SERVICE BULLETIN

ENGINE - FUEL AND CONTROL - TO PROVIDE A NEW ELECTRONIC ENGINE CONTROL (EEC) WITH THE
SCN11B SOFTWARE CONFIGURATION - CATEGORY CODE 4 - MOD.ENG-73-0079

V2500-ENG-73-0079

REMOVE THE 808050-04-025
(2A3130) ELECTRONIC ENGINE
CONTROL AND INSTALL THE
808050-4-029 (2A3189) ELEC-
TRONIC ENGINE CONTROL (1 off)

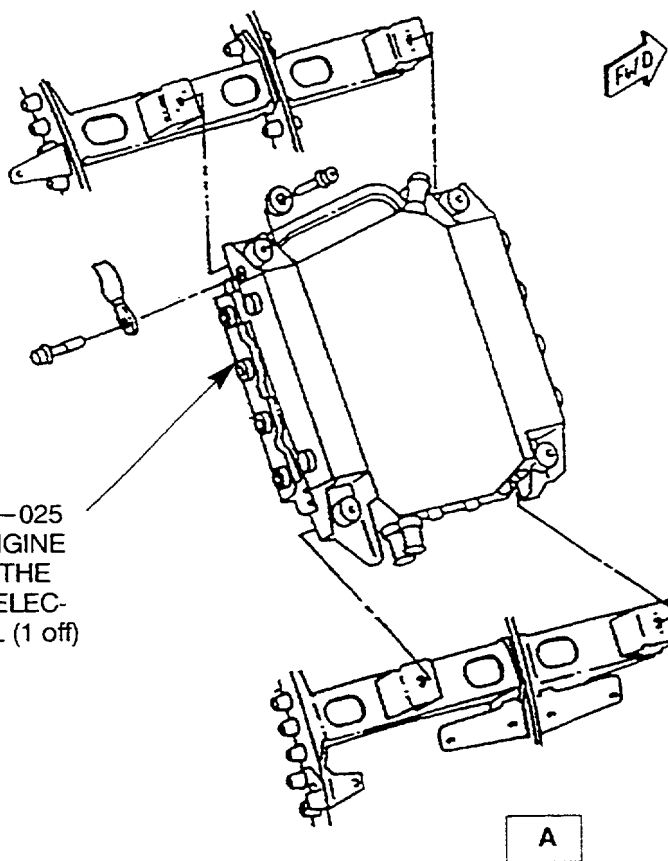
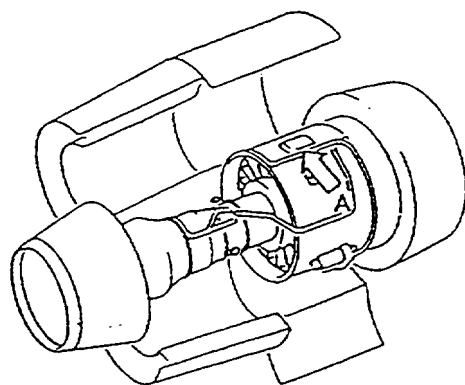
- (1) Remove the 808050-04-025 (2A3130), Electronic Engine Control by the approved procedure given in Reference (3), Chapter/Section 73-21-34, Removal/Installation. Refer to Figure 1.

- (1) Install the 808050-4-029 (2A3189), Electronic Engine Control (1 off) by the approved procedure given in Reference (3), Chapter/Section 73-21-34, Removal/Installation. See Figure 1.
